# KEMNAY COMMUNITY COUNCIL

## **Planning Application APP/2015/1107**

### **Erect 66 Houses at Bogbeth Road (Land East Of Greystone Road), Kemnay.**

**KCC Fig. 4. Proposed Main Access and Limited Access**

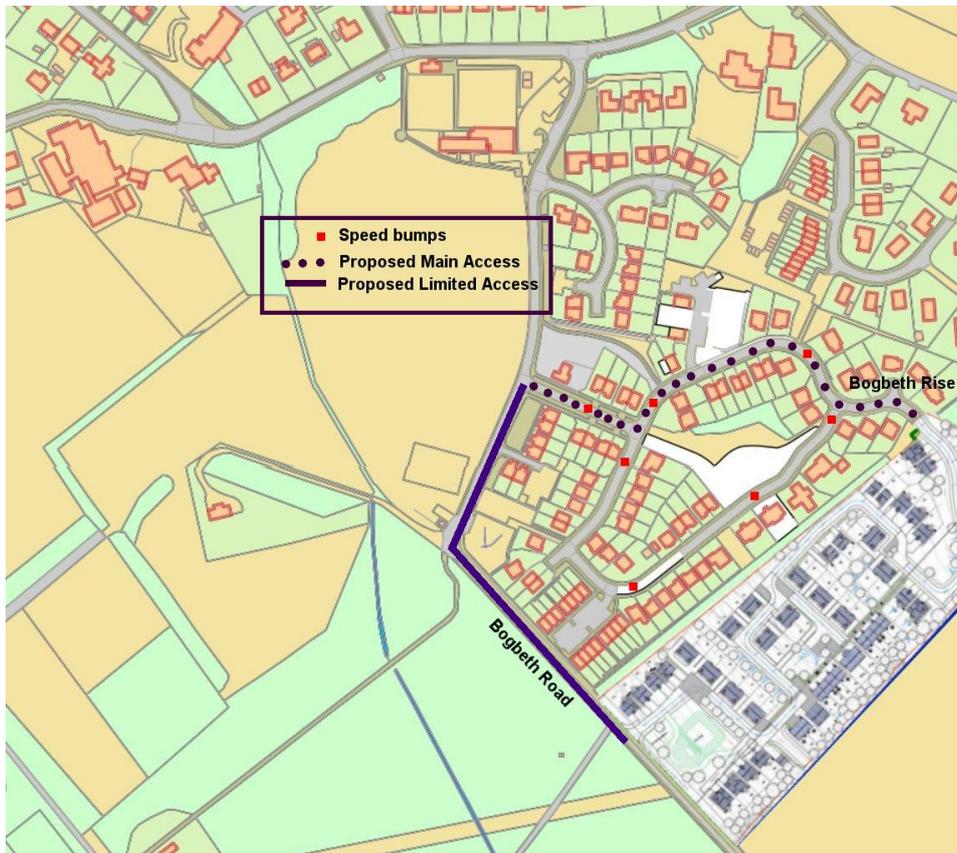
This suggests that the main access to the site will be from Bogbeth Rise which will involve taking a meandering road, negotiating traffic calming measures and many parked cars through the existing development to the north. Paragraph 3 goes on to describe the access on to Bogbeth Road as “limited “. DAS Fig. 8 describes the access on to Bogbeth Road as “Restricted” and DAS Fig. 9 describes the same access as “Secondary”. However, 4.5 Layout and Design para. 4 directly contradicts the former statements by stating that the secondary access is Bogbeth Rise to the north through the existing development and that the main access is to the south west which connects the development to Bogbeth Road and the town centre. As stated previously we disagree that Bogbeth Rise will be the main access, the natural access by choice and desire will be via Bogbeth Road.

There can surely be no doubt that Bogbeth Road will be the main entrance to this proposed development. It is clear that Bogbeth Road is being proposed as a limited secondary access in order to avoid additional development costs involved in widening the road and providing a linking footpath. The Developer should widen Bogbeth Road and provide a footpath from the proposed development access road to link with the existing footpaths that end at the car park opposite the Skatepark and also link to the footpath to Kemnay Primary School. If Bogbeth Road is not widened and a linking footpath is not provided, it will inevitably result in future pressure from the community for such to be provided by Aberdeenshire Council. It is disappointing that Halliday Fraser Munro did not effectively and adequately consult with the community on this application, had they done so the issue of road widening and footpath provision along Bogbeth Road could have been incorporated into the development plan and as a result this application may not have attracted so many objections.
